BULLETIN NUMBER:
SB13-04-S003A

SAFETY RECALL 13V-248

DRIVER DOOR SWITCH SHORT CIRCUIT

- 2006-2007MY Isuzu Ascender Vehicles

Figure 1 – Driver Side Door Lock & Side Window Switch

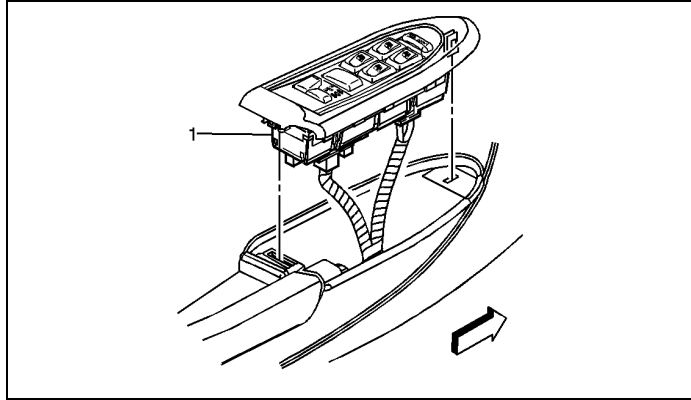
1. Remove the driver side door lock and side window switch. Refer to *Door Lock and Side Window Switch Replacement - Driver Side* in the service manual.

2. Determine the part number on the driver side door lock and side window switch. The part number is on the side of the switch on the label.
 - a) If the part number on the switch is listed in the parts table above, no repair is required. Re-install the driver side door lock and side window switch. Refer to *Door Lock and Side Window Switch Replacement – Driver Side* in the service manual, and then proceed to Step 3, “Applying the Campaign Label”.

- b) If the part number on the switch is NOT listed on the table above, replace the driver side door lock and side window switch. Refer to *Door Lock and Side Window Switch Replacement – Driver Side* in the service manual.
